Airworthiness Directive

DCA/750XL/8 Fuselage Roof, Station 180.85 – Inspection and Repair

PACSB / XL / 019

INSPECTION – Fuselage roof, Station 180.85

Figure 1

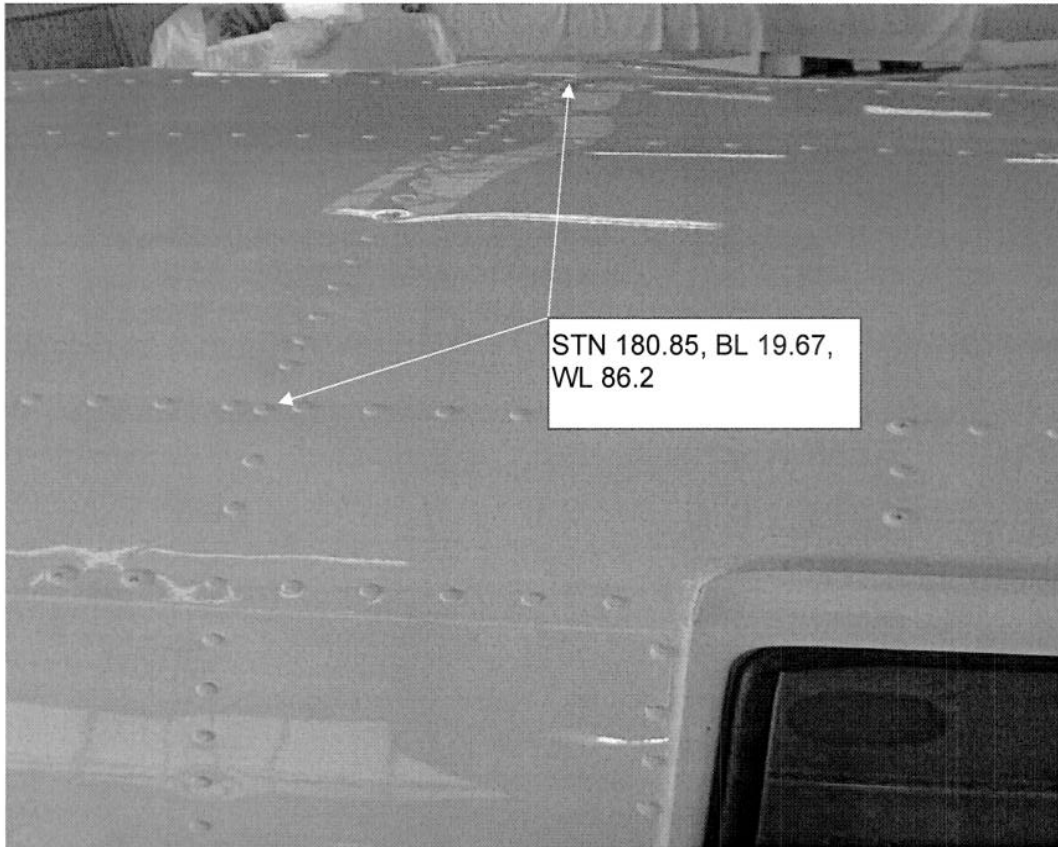
During routine inspection of an aircraft during release to service at Pacific Aerospace Corporation, it was identified that a row of 1/8" solid rivets had been incorrectly fitted where 5/32" solid rivets had been specified in the fuselage top (43 locations). STN 180.85, BL 19.67, WL 86.2 (Fig 1)

- 2.1 At the co-ordinates specified visually inspect to determine that the correct rivet 5/32" has been installed. Using aids as necessary, (e.g. verniers) examine the rivet heads in the positions indicated. Refer to the illustration (Fig 1) which shows the fuselage roof.
- 2.2 The rivet heads at the points arrowed should be those of 5/32" rivets, clearly larger than those (1/8"). As a guide the head of the 5/32" rivet should measure \varnothing 0.327" the incorrect 1/8" rivet head size should measure \varnothing 0.289".
- 2.3 If rivets are 5/32", no further work is required complete section 4.0 of this SB.
- 2.4 If the rivets appear to be 1/8", proceed as in part 3.0.

- 3.1 Incorrect rivets to be removed and replaced using the following rivet type MS20470AD5 (43). Components are available from Pacific Aerospace Customer Service.
 - Referring to the Maintenance Manual, Chapters 25 & 53 remove the Roof cabin linings.
 - Drill the heads and remove the 1/8" rivets one at a time, following normal rivet removal procedure.
 - As each rivet is removed, drill the hole out to 5/32", then ream using a number 21 (0.159") ream.
 - Install and drive an MS20470AD5 rivet.
 - Proceed until all 43 affected rivets have been replaced.
 - Paint in accordance with standard aircraft practices refer to Maintenance Manual Chapter 20.
- 3.2 Reinstall the cabin lining referring to the Maintenance Manual, Chapter 25.
